**ADDENDUM
NO. 01**

July 31, 2024

Renovation of Fall Creek Intermediate School
12011 Olio Road
Fishers, IN 46038

1 TEMPORARY CLASSROOM PLAN_GYMNASIUM
SCALE: 1/8" = 1'-0"

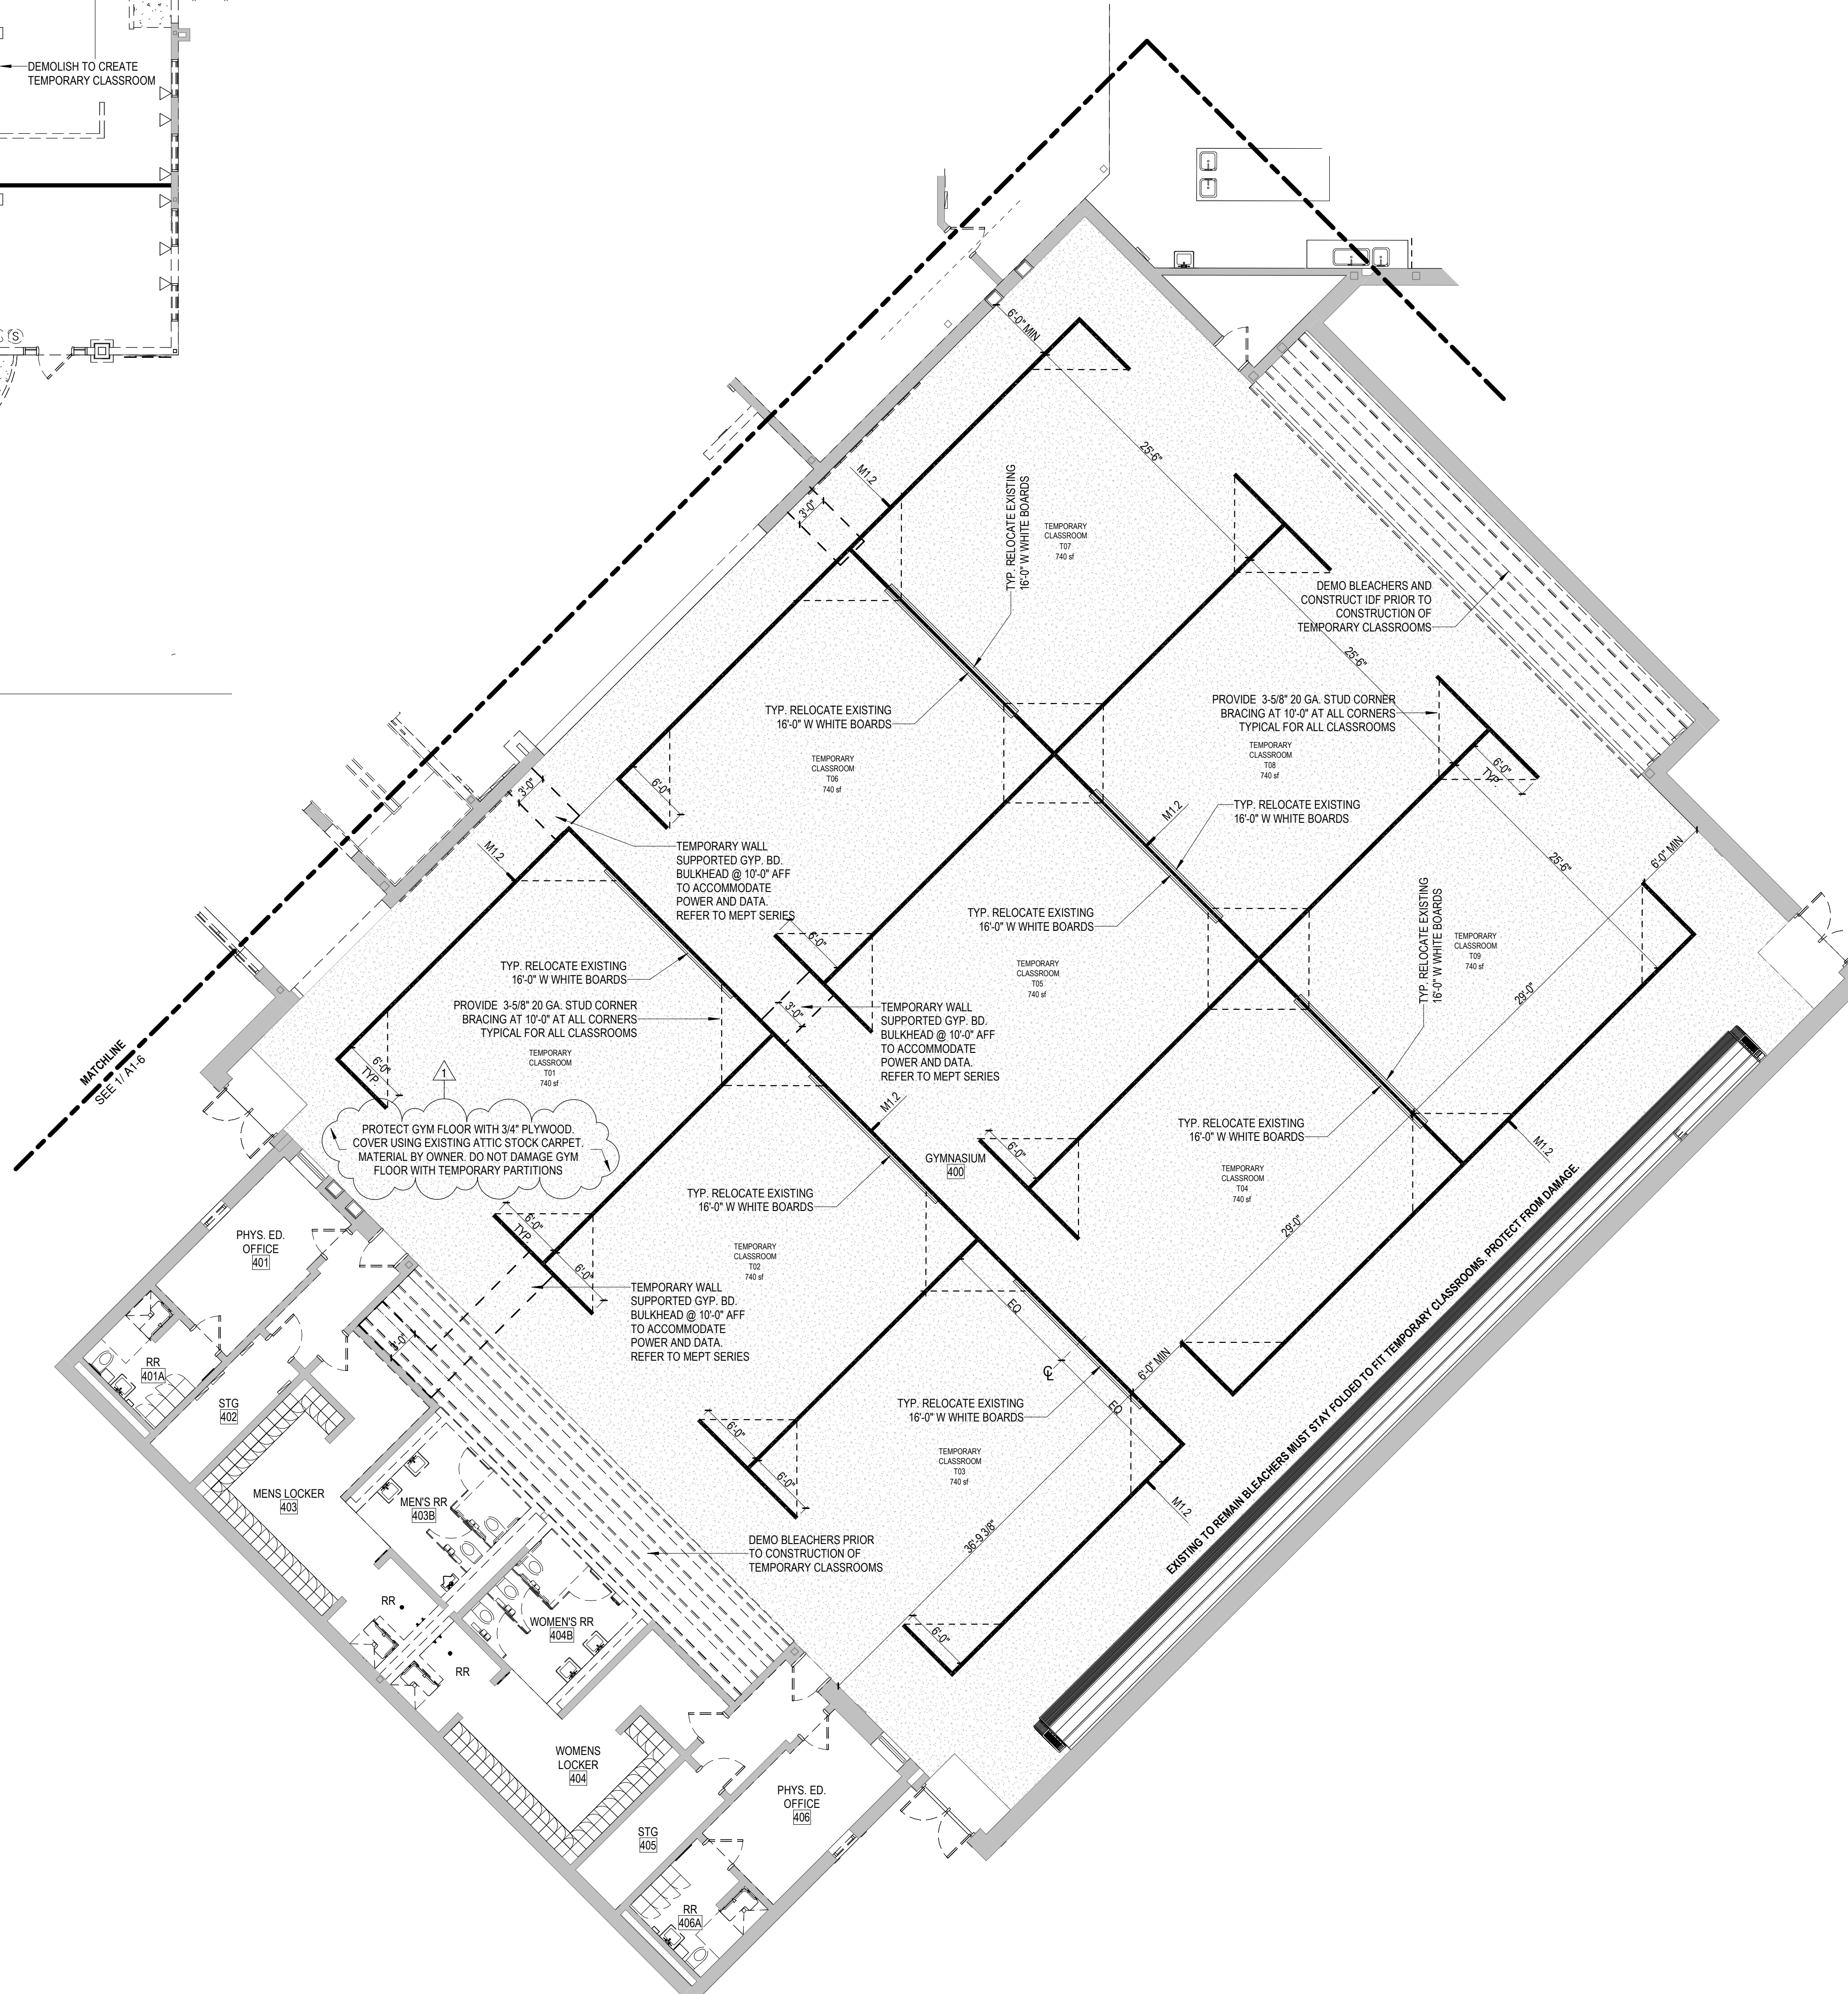
Sheet G0-4 Temporary Classroom Plan

- Add note to protect gymnasium floor with ¾" plywood prior to temporary carpet installation

DRAWING NO.
M4-1

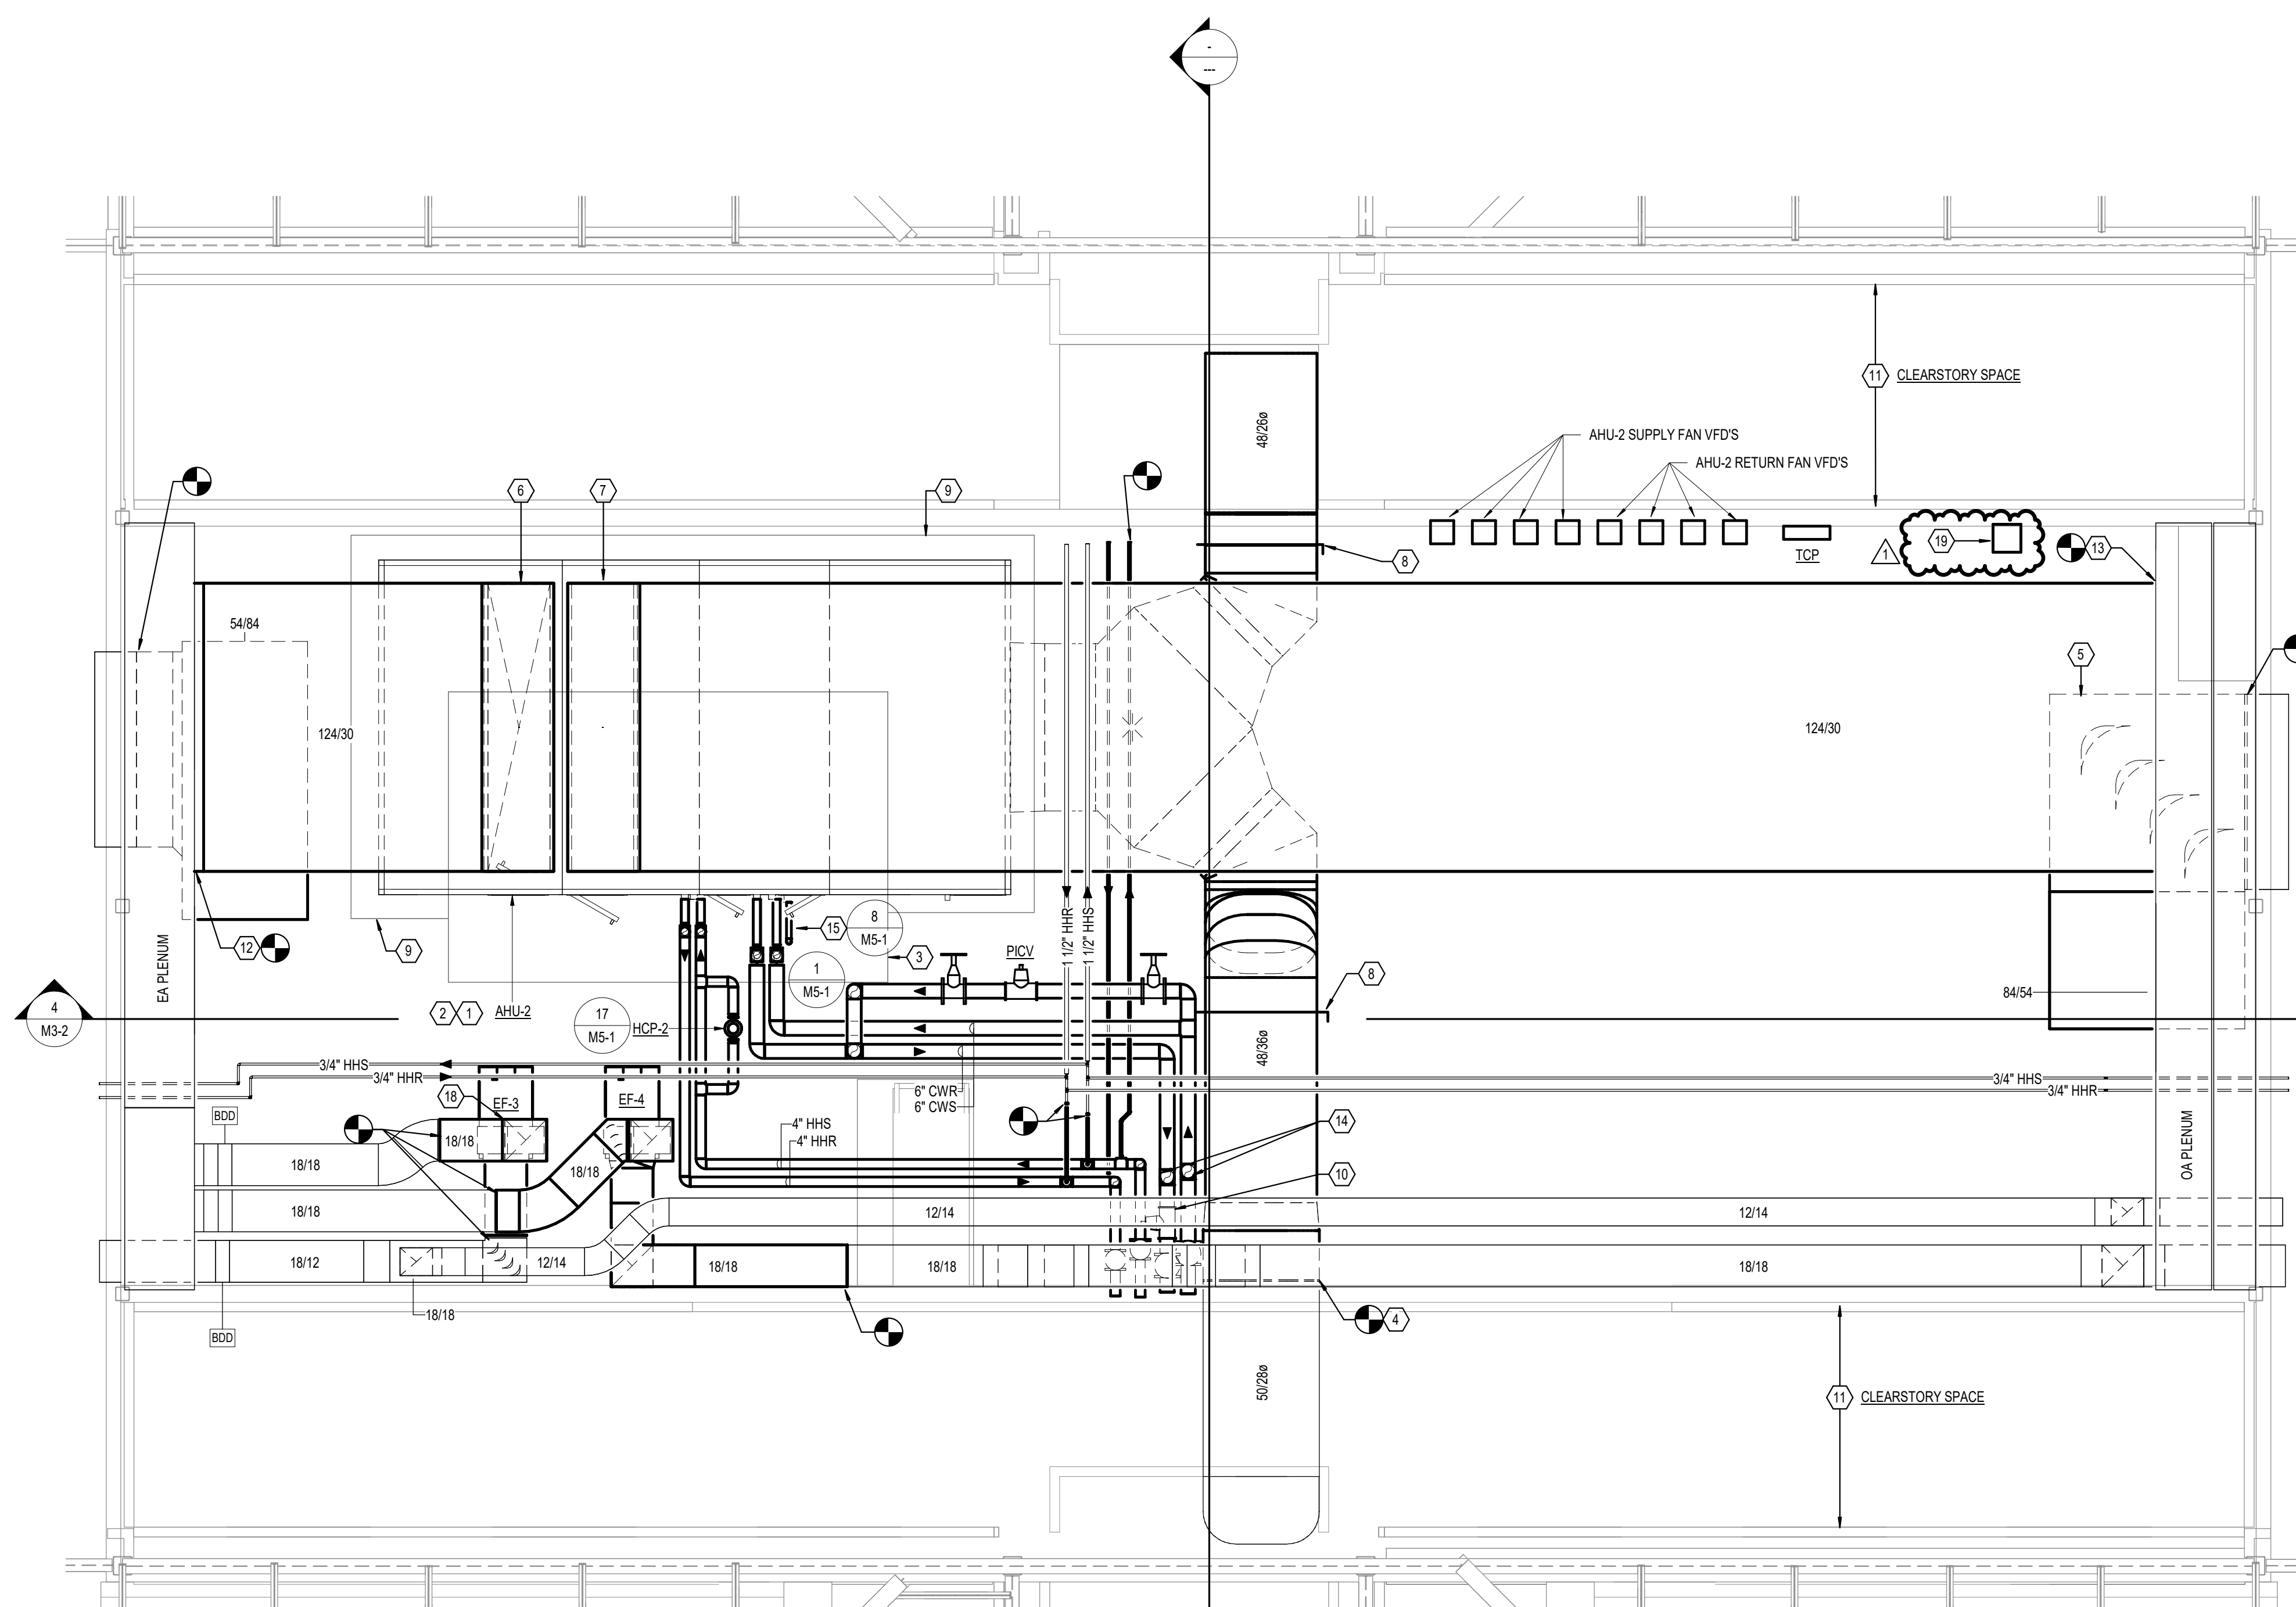
Sheet M4-1 ENLARGED MECHANICAL PLANS

1. Added plan note #19.
2. Added low voltage controls transformer.
